# Access Compliance Report

## Public Rights-of-Way (Curb Ramps)

Intersection ID: 3105		Main Street: DEARMON_RD		Cross Street: BROWNE_RD		Location: NE																																																																																																																																																									
ADA ID: F70E7067AF5A		Ramp Type: Directional1		Initial Pass/Fail: Fail		Overall Compliance: No		Severity Score: 13.75																																																																																																																																																							
Codes/Mitigation Info/Possible Solution				Field Measurements/Component Compliance																																																																																																																																																											
<div></div> <div>Street 1 Name BROWNE RD</div> <div>Stop Condition-Street 1 None</div> <div>Street 2 Name N/A</div> <div>Stop Condition-Street 2 N/A</div>				Possible Solutions:

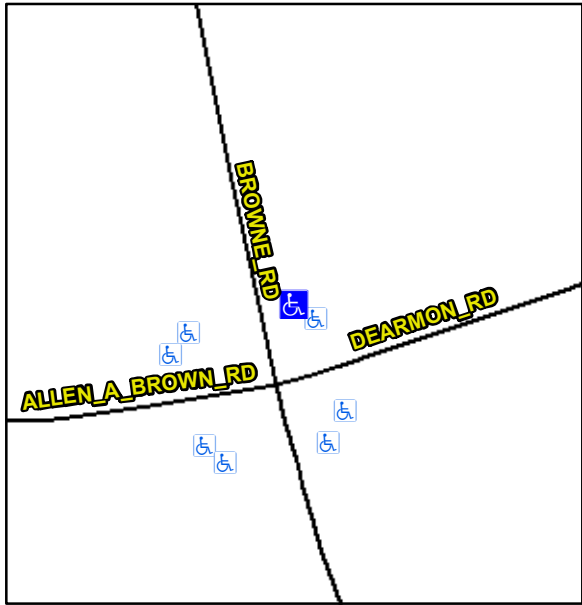
<table><tr><th>Compliance</th><th>Description</th><th>Data</th><th>Compliance</th><th>Description</th><th>Data</th></tr><tr><td>No</td><td>Ramp Slope (%)</td><td>8.5</td><td>N/A</td><td>Grade Break XSlope (%)</td><td>0.0</td></tr><tr><td>No</td><td>Ramp XSlope (%)</td><td>3.1</td><td></td><td></td><td></td></tr></table>
